**GOVERNMENT/INDUSTRY AERONAUTICAL CHARTING FORUM**  
**Instrument Procedures Group**  
**May 1, 2007**  
**HISTORY RECORD**

**FAA Control # 07-01-274**

**Subject:** AIM Information Regarding ODP Minimum Crossing Altitudes

**Subject: Minimum Obstruction Clearance Altitudes Depicted on Standard Instrument Departures (SIDs)**

# ZEFFR THREE DEPARTURE (RNAV)

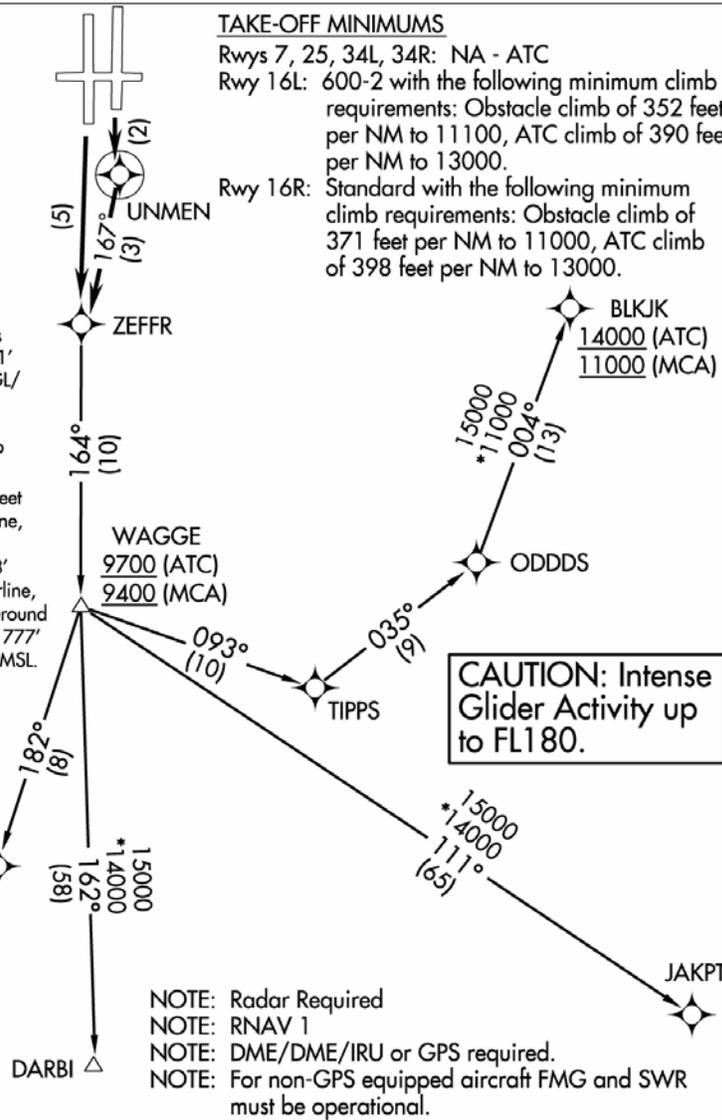
**Background/Discussion:** FAA Order 8260.46C, Departure Procedure Program, paragraph 10(f)(1), Charting Minimum Altitudes, requires that SIDs (both conventional and RNAV) must depict minimum altitudes for obstruction clearance; and, where appropriate, any required minimum ATC altitudes. Where these differ, documentation of both minimum altitudes is required on the 8260-15 form. Appendix 5 (Non-RNAV DP's) and Appendix 6 (RNAV DP's) of this Order require that SIDs accommodate ATC and obstruction clearance requirements by documenting the ATC altitude followed by the altitude required for obstruction clearance. Charting agencies must depict the obstruction altitude as a minimum crossing altitude (MCA). An example of the application of this requirement may be seen on the attached ZEPHR THREE RNAV SID at Reno, NV (RNO).

(EDETH1.EDETH) 07354  
**EDETH ONE DEPARTURE (RNAV)**

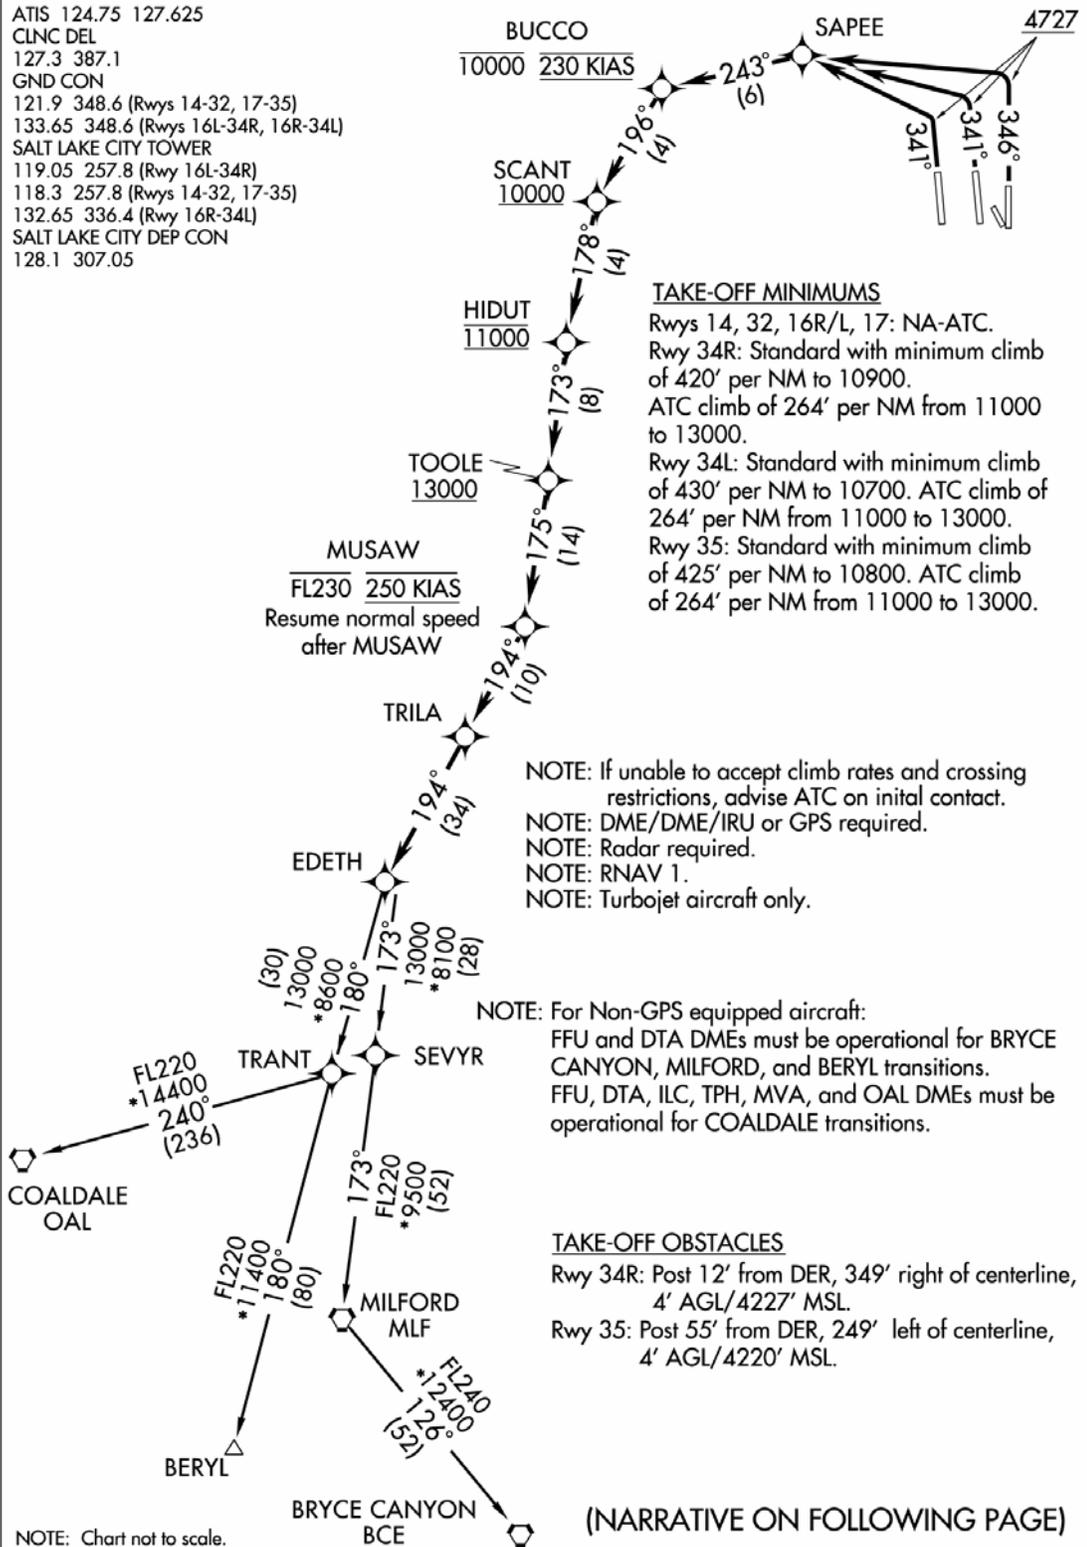
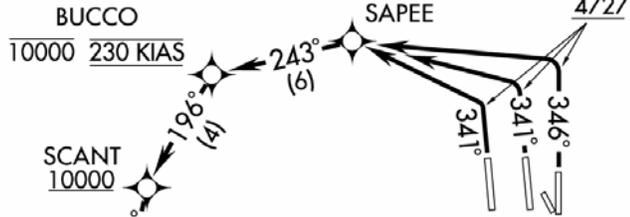
Some recently published Graphic DP's fail to depict minimum obstruction clearance altitudes in accordance with the above stated requirements. Two examples of SIDs that do not comply are the EDETH ONE (RNAV) at Salt Lake City, UT (SLC) and the GABRE SIX at Los Angeles, CA (LAX), both of which are attached. Further, there are several other Graphic DPs currently in coordination that also fail to depict the minimum altitudes for obstruction clearance.

*All Graphic DP's should be designed and charted in accordance with the criteria contained in FAA Order 8260.46C with respect to fix minimum altitudes for obstruction clearance (MCA) and for air traffic purposes (ATC). Further, the future revision to the 8260.46 Graphic DP's should require the charting of the applicable MOCA for all non-vector procedure legs.*
